### **REMARKS/ARGUMENTS**

Claims 1-4 are currently amended. Corrected drawing sheets, replacing drawing pages 1 and 2 which contain Figs. 1 and 2, are attached.

Fig. 2  
PRIOR ART

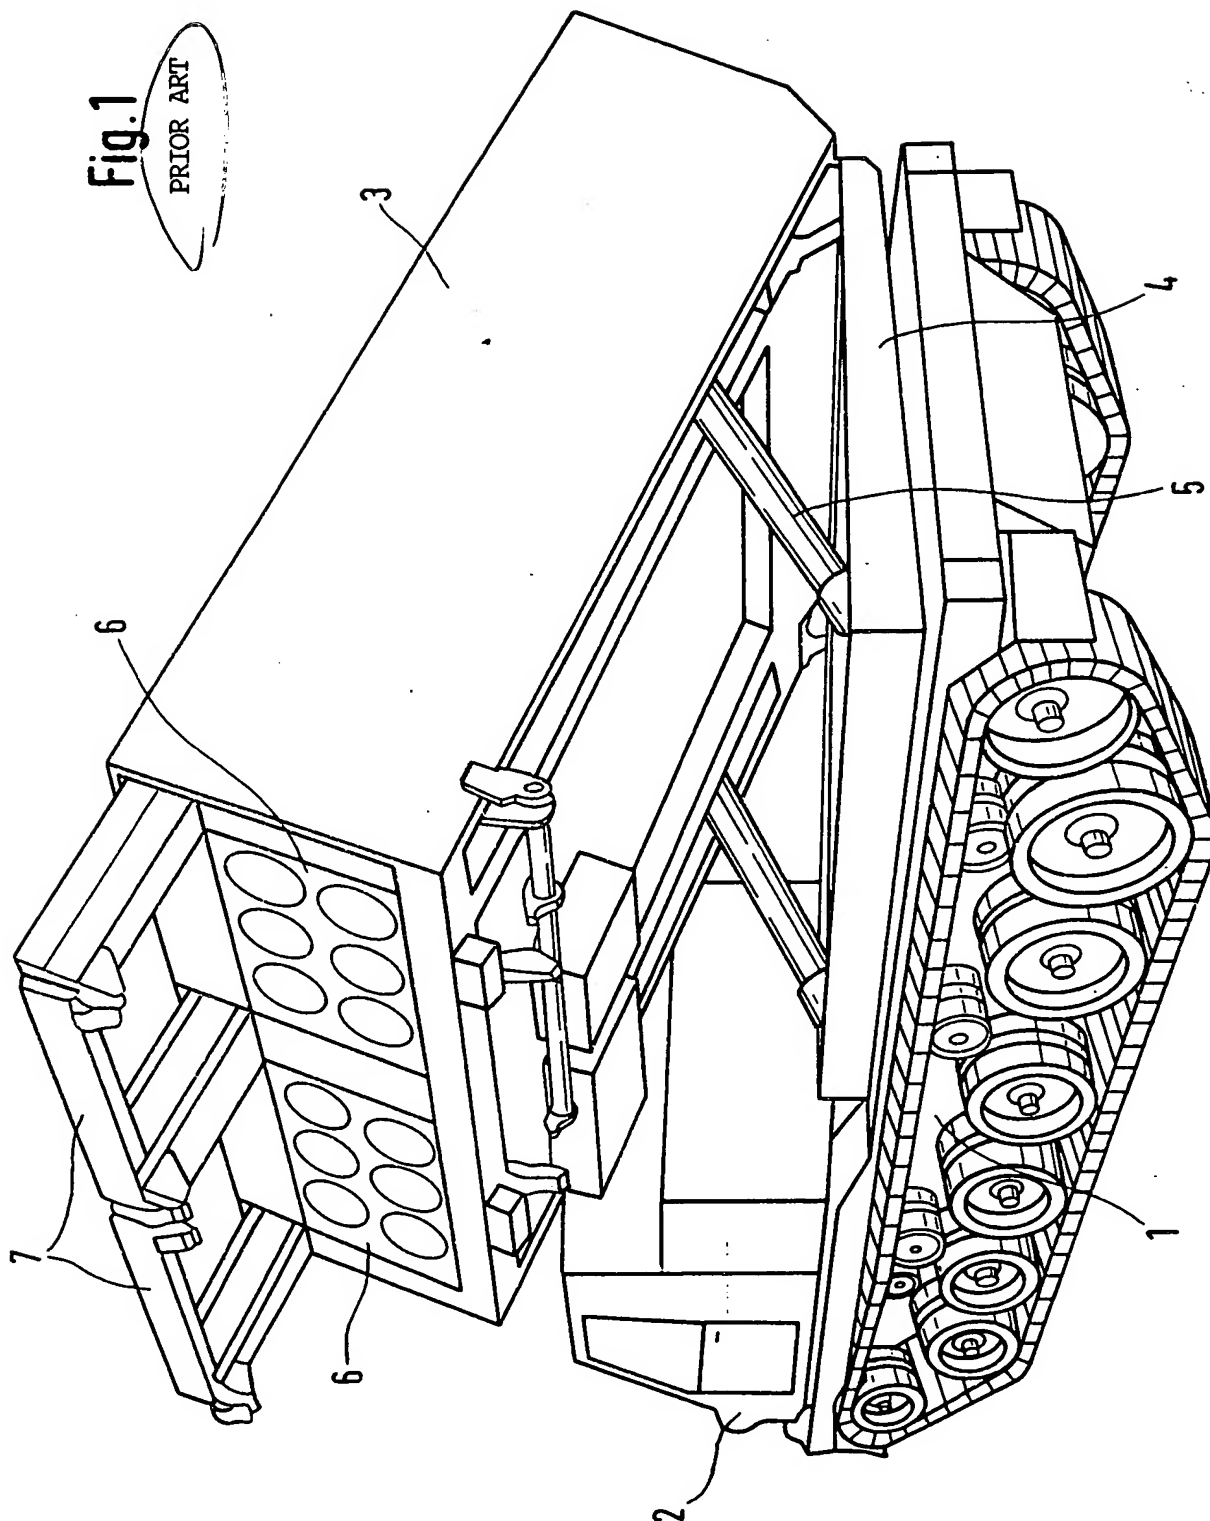
The Examiner has objected to the drawings, indicating Figs. 1 and 2 should be indicated as "Prior Art". The Applicant appends replacement drawing pages in response hereto.

The attached sheets of drawings include changes to Figs. 1 and 2. These sheets replace the original sheets containing those same figures and include the legend "PRIOR ART". Fig. 3 is unchanged but is included for drawing uniformity
